Office Action Summary	Application No. 10/531,786	Applicant(s) WEINSTEIN ET AL.	
	Examiner Krishnan S. Menon	Art Unit 1797

DETAILED ACTION

Claims 11-19 are pending as amended 4/9/08

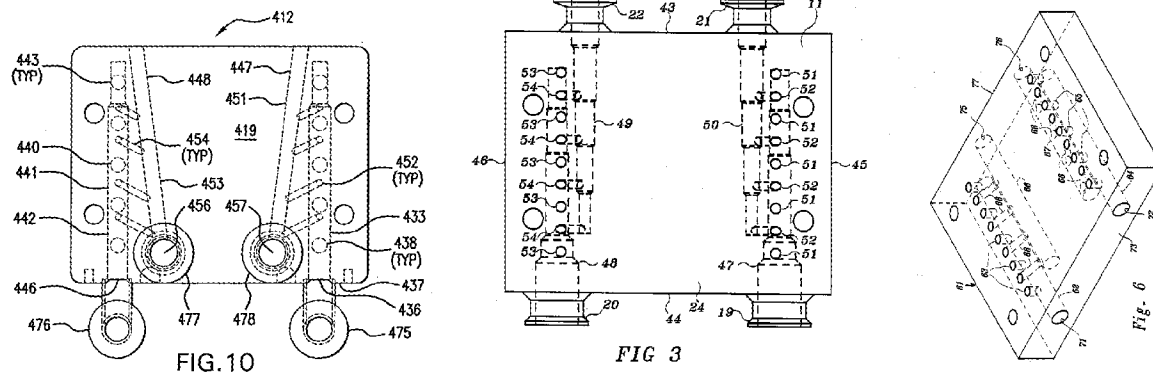
Claims 1-10 are rejected under 35 U.S.C. 103(a) as being unpatentable over Latour et al (US 4,849,102) and/or Friedman (US 4,715,955).

Applicant's figure 10, assumed to be best representing the claims in comparison with figure 5 of Latour and figure 6 of Friedman.

Latour teaches a filtration housing and cassette assembly (12, see figures), in which the housing comprises first and second parallel plates (11,13,14), plate 11 having feed inlet (19) and retentate outlet (20) channels at opposite edges, and filtrate channels (21,22) having first portions (49,50) and second transverse portions (connecting 49 to 54 and 50 to 52) as claimed. These channels communicate with the respective feed, retentate and filtrate channels of the cassettes. The plates are movable on frames to change the number of cassettes loaded as desired.

The teaching of the reference differs from the claims in the 'acute' orientation of the transverse filtrate channels with respect to an upper surface of the first end plate. Friedman teaches the transverse filtrate channels as being at an acute angle with a face of the end plate, but this does not appear to be the "upper surface" as claimed. The [first] plate (11) of Latour is also a central plate (communication to the filter cassettes from both major surfaces), whereas the applicant depicts it as an end plate (communication to the cassettes only from one major surface). Latour refers to Friedman and teaches his design as an improvement over that of Friedman, who has the plate with inlet and outlet channels at and end. However, the "acute" orientation of the transverse filtrate channel is only an obvious design change in shape and/or orientation, which one of ordinary skill in the art is capable of; and are not patentable unless can be shown otherwise. Changes of size, shape, etc without special functional significance are not patentable. *Research Corp. v. Nasco Industries, Inc.*, 501 F2d 358; 182 USPQ 449 (CA 7), cert. denied 184 USPQ 193; 43 USLW 3359 (1974). Applicant has not demonstrated any criticality of having the acute angles in the transverse filtrate channels to overcome a prima facie case of obviousness.
